ADDENDUM NO.1

Re: **Kennebec Valley Community College**
Fairfield, Maine

Radiology Lab Renovations

Bid RFI's

Structural Layout - Ceiling

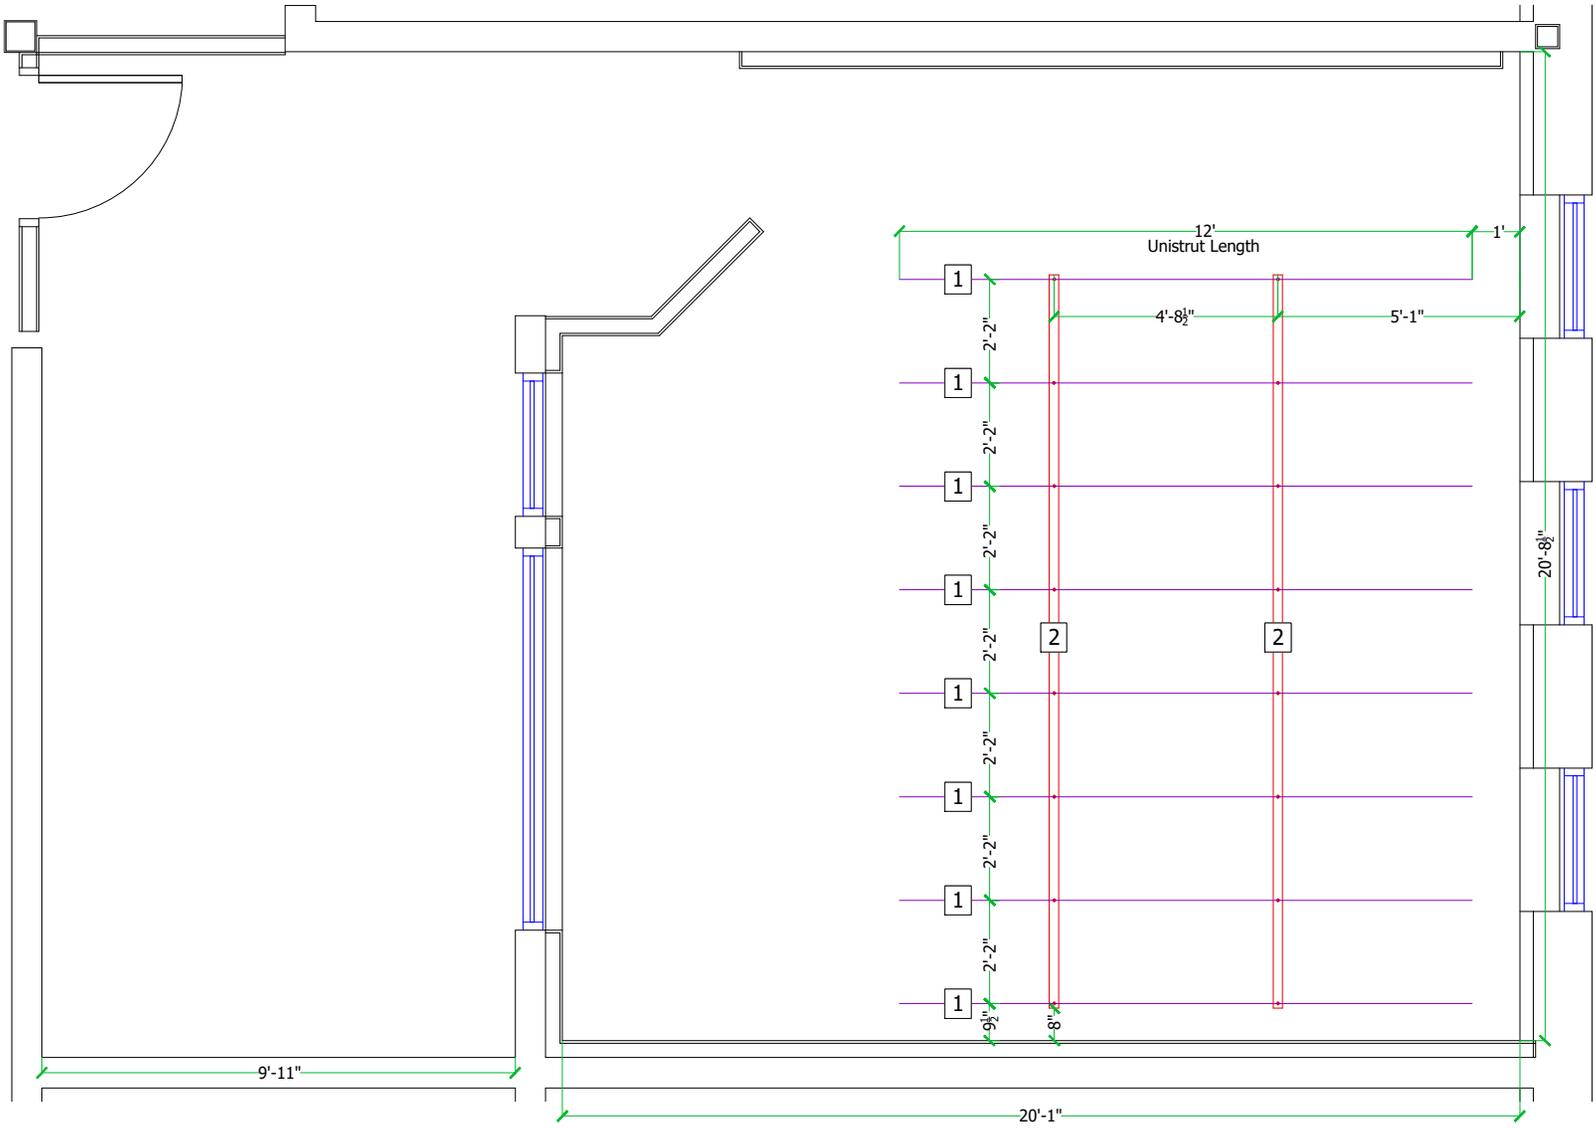
1. Which joists are to be reinforced? Where are the concentrated loads? See sec. s1.1.

Which joists require reinforcement will depend on the Unistrut design submittal to be issued by the Contractor for our review. Our structural plan shows the conceptual layout that we were given during the Design Phase, but this is subject to change as it is finalized by the Contractor thru a delegated design with the Unistrut vendor/engineer. Based on the conceptual layout, we are anticipating there being five joists from which the Unistrut system will be hung. These joists would require supplemental angle web members per our Typical Detail if the points of attachment do not occur at existing panel points.

1 E000 KEY PLAN

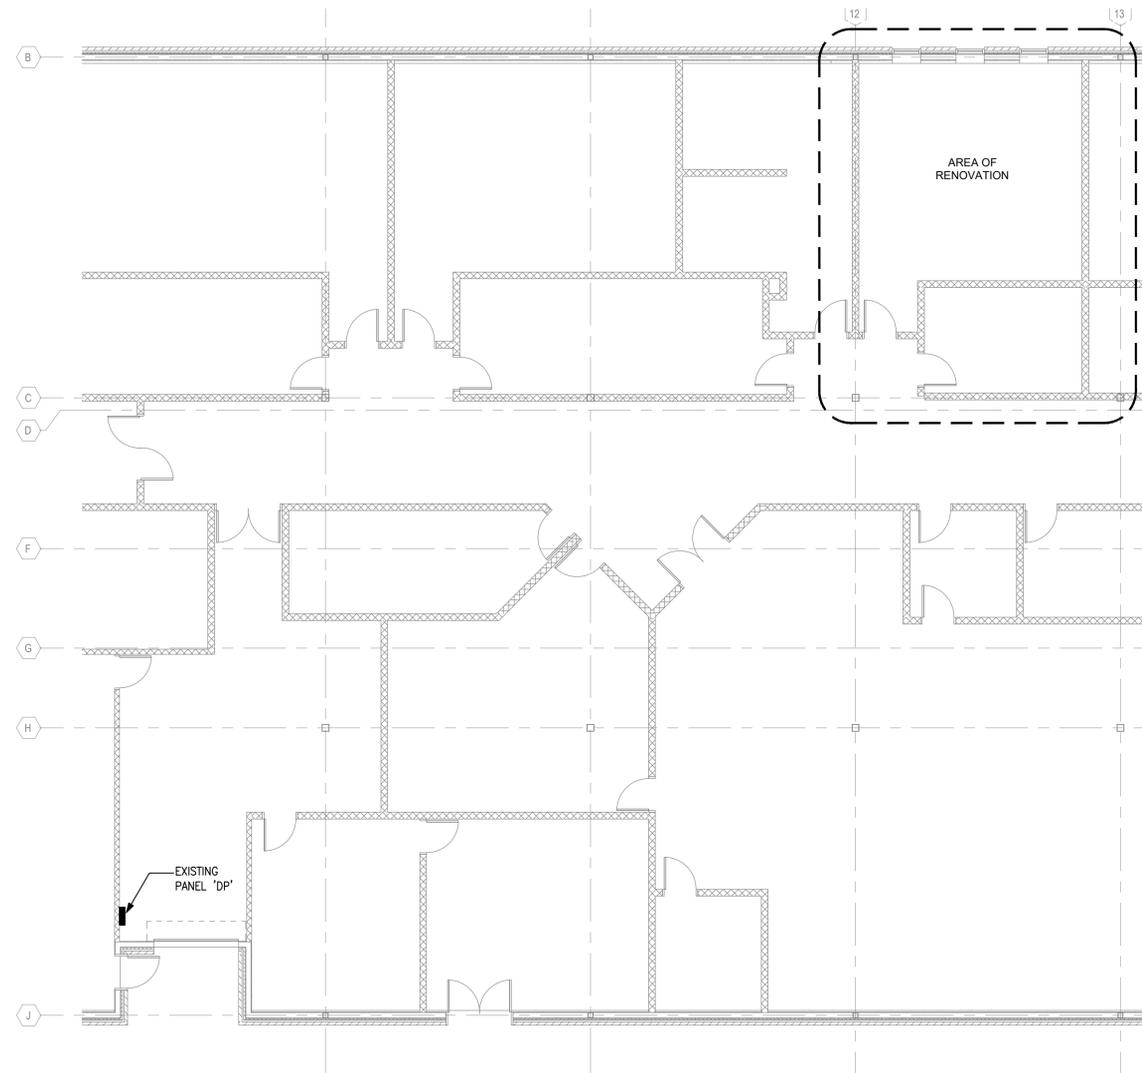
4. There seems to be a discrepancy with the amperage rating of panel RP between note 22 feeder schedule and the panel schedule on page E000.

Refer to revised E000 drawing within Addendum 1.

E7 DOOR AND FRAME ELEVATION
A1.1 1/4" = 1'-0"

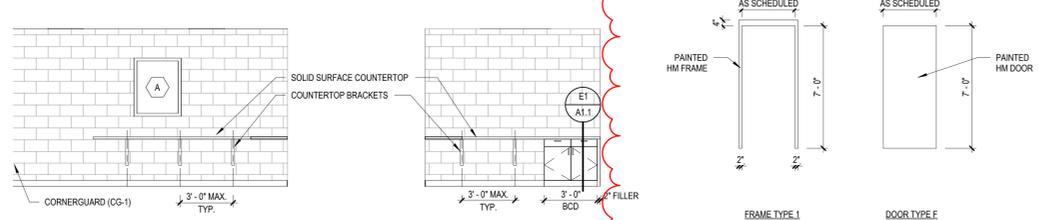
2. The door schedule states a type F door. Not seeing in the plans what a type F door consists of. See sec A1.1 in door schedule.

Door Type F is a flush door (no glass or stiles/rails). See Addendum No. 1.
